MEMORANDUM

SUBJECT: 2023 Road Program Tree Evaluation

2023 ROAD IMPROVEMENT

SUMMIT AVENUE TRUCITON PLAN

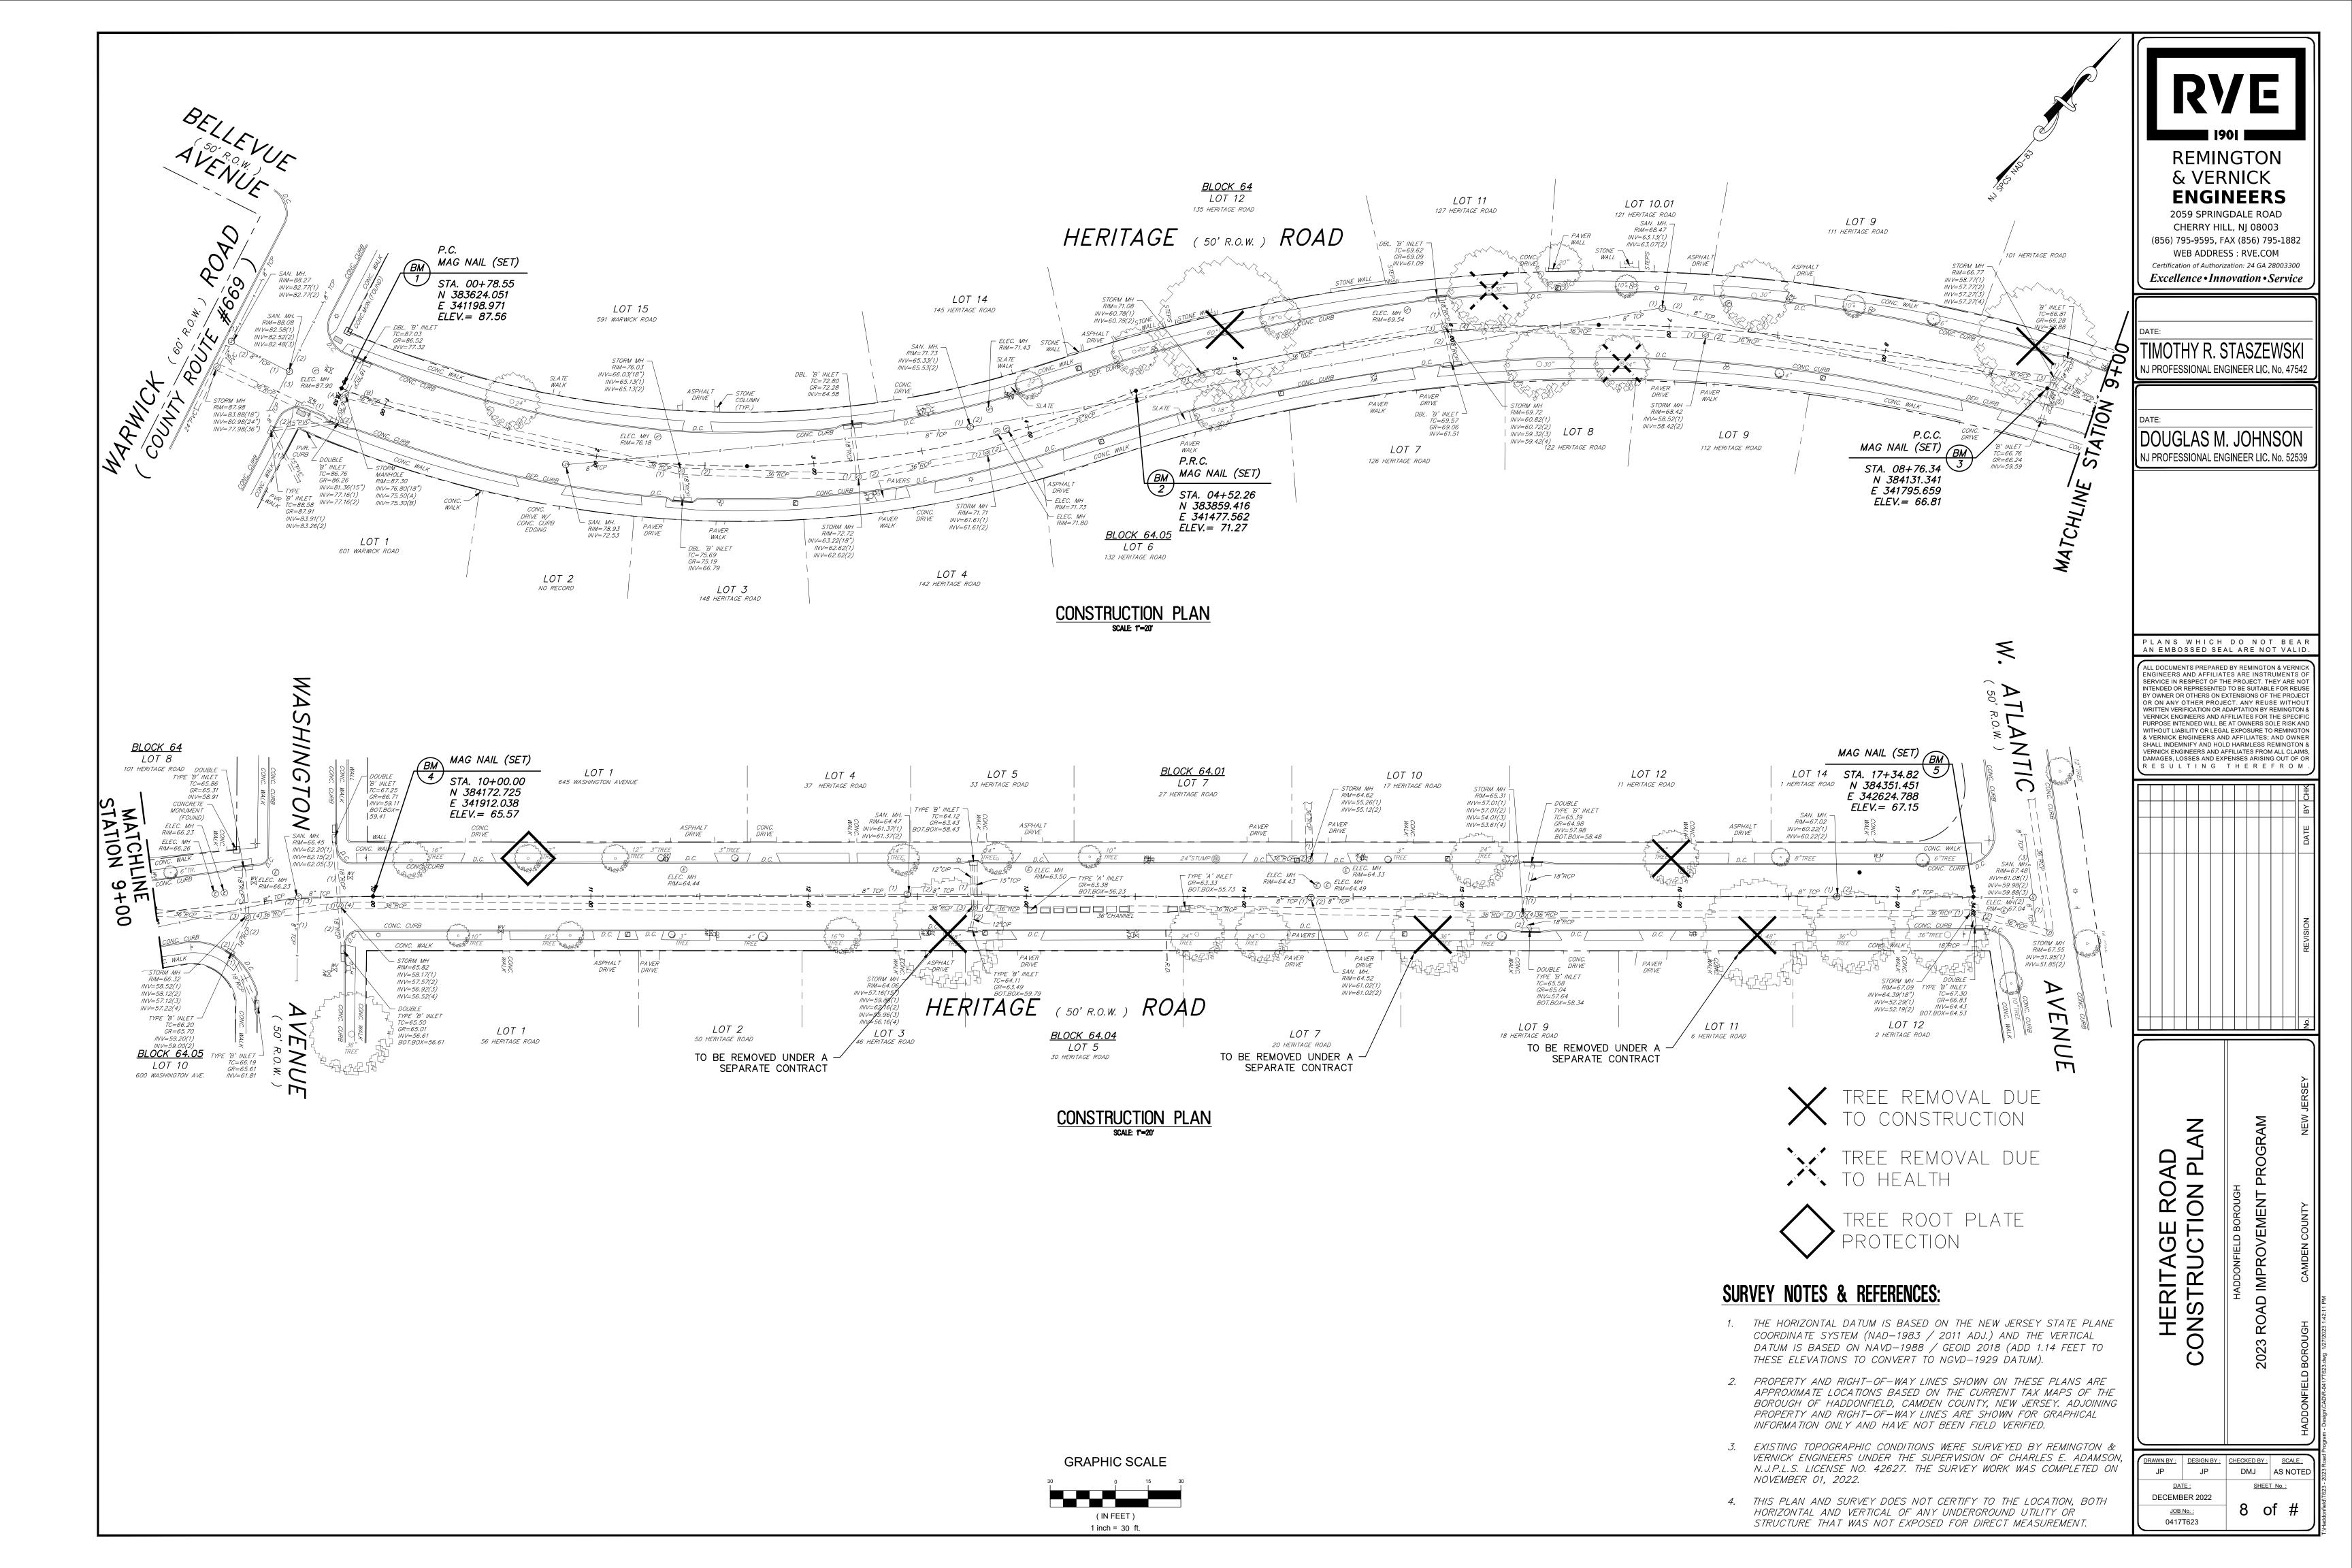
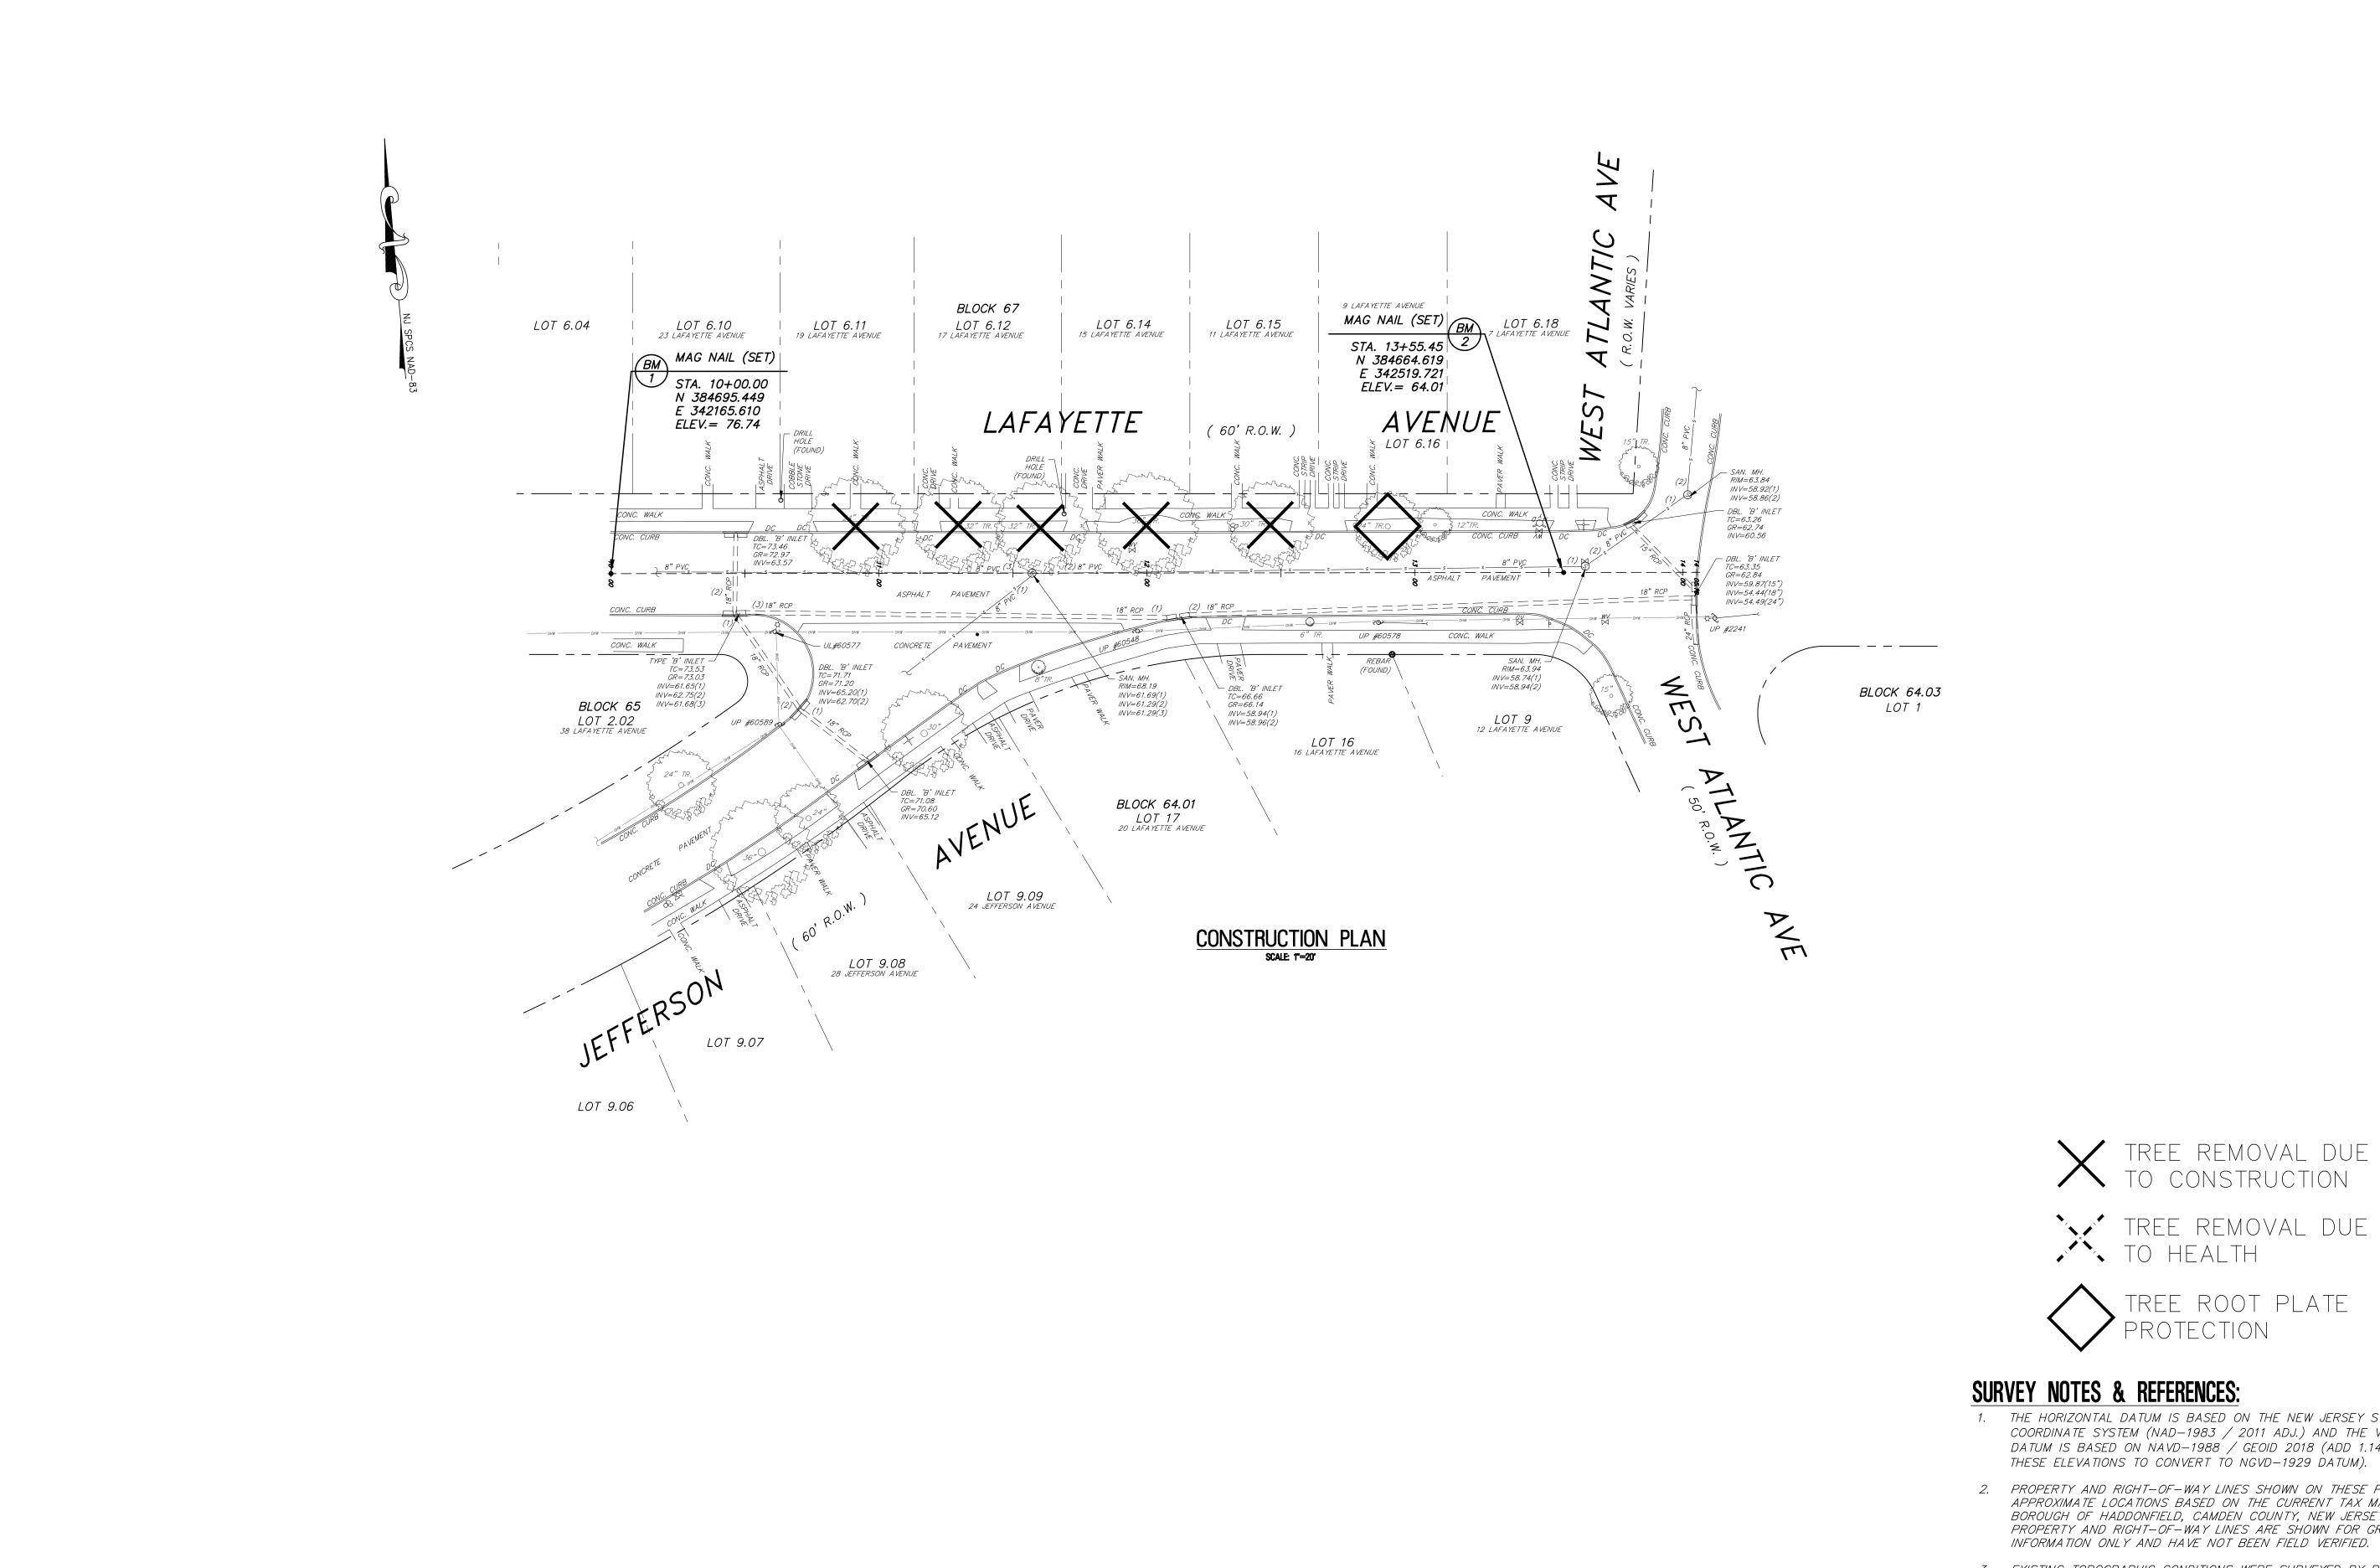
7 W Summit Avenue	20" Honey Locust (F1) is in	Tree to be removed
	poor condition that overhangs the curb and the road	due to poor condition
17 W Summit Avenue	10" tree in poor condition	Tree to be removed under separate contract
25 W Summit Avenue	20" Ash (S1) is in poor condition	Tree to be removed due to poor condition
11 Heritage Road	20" Sugar Maple (F1) is in good condition and overhangs part of the curb and road	Tree to be removed due to construction
645 Washington Avenue	14" Willow Oak (S1) is in good condition and slightly pushes the curb out	Tree root protection plate to be installed
101 Heritage Road	48" Pin Oak (F1) is in OK condition but and overhangs part of the curb and road	Tree to be removed due to construction
127 Heritage Road	34" Pin Oak (F1) is in poor condition and overhangs part of the road and sidewalk	Tree to be removed due to poor condition
135 Heritage Road	60" Pin Oak (F1) is in good condition and overhangs part of the curb and road	Tree to be removed due to construction
